Access Compliance Report

Public Rights-of-Way

Intersection ID: 48581	Main Street: WATERLILY_LN	Cross Street: RUMPLE_RD	Location: NE
ADA ID: 113F34143821	Ramp Type: BlendTrans1	Initial Pass/Fail: Fail	Overall Compliance: No
		Severity Score: 8.75

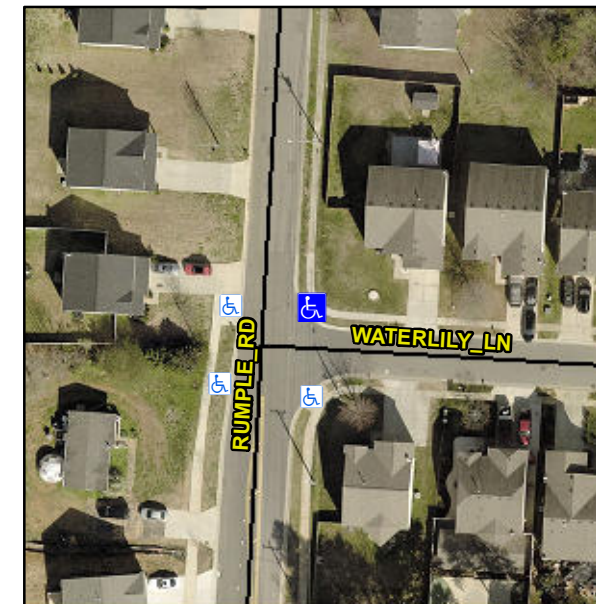
Not Found, R304.5.1

Compliance	Description	Data	Compliance	Description	Data
N/A	Ramp Length (in)	47.0	Yes	BlendTrans Slope (%)	3.6
No	Ramp Width (in)	47.0	Yes	BlendTrans XSlope (%)	1.2
N/A	Flare Type LT	N/A	N/A	Flare Type RT	N/A
N/A	Flare Slope LT (%)	N/A	N/A	Flare Slope RT (%)	N/A
N/A	Flare Traversable LT?	N/A	N/A	Flare Traversable RT?	N/A
N/A	Landing Length (in)	N/A	N/A	DWS Provided?	N/A
N/A	Landing Width (in)	N/A	N/A	DWS Contrast?	N/A
N/A	Landing Slope (%)	N/A	N/A	DWS Length (in)	N/A
N/A	Landing X Slope (%)	N/A	N/A	DWS Full Width?	N/A
N/A	Landing Curb? (Y/N)	N/A	N/A	DWS Offset (in)	N/A
N/A	Shared Landing?	N/A			
N/A	Gutter Ponding?	N/A	N/A	Gutter Slope (%)	N/A
N/A	Gutter Lip Ht (in)	N/A	N/A	Gutter X Slope (%)	N/A
N/A	Painted X Walk1?	No	N/A	Painted X Walk2?	No
	X Walk 1 Direction	To W		X Walk 2 Direction	To S
	X Walk 1 Width (in)	N/A		X Walk 2 Width (in)	N/A
	X Walk 1 Slope (%)	3.3		X Walk 2 Slope (%)	1.1
	X Walk 1 X Slope (%)	1.6		X Walk 2 X Slope (%)	2.0

N/A	Ramp inside XWalk1?	N/A	N/A	Ramp inside XWalk2?	N/A
	Road Slope (%)	0.3		Clear Space?	N/A
	Road X Slope (%)	2.7	N/A	Clear Space to XWalk (in)	N/A
N/A	Any Obstructions?	N/A	N/A	Storm Grate/Utility Hazard?	N/A
	Obstruction Type			Storm Grate/Utility Type	
		N/A			N/A
			Yes	Surface Condition? (G/P)	Good
			No	Curb Slope (%)	10.3

Remove & Replace Curb Ramp With Two New Directional Ramps or Equivalent.
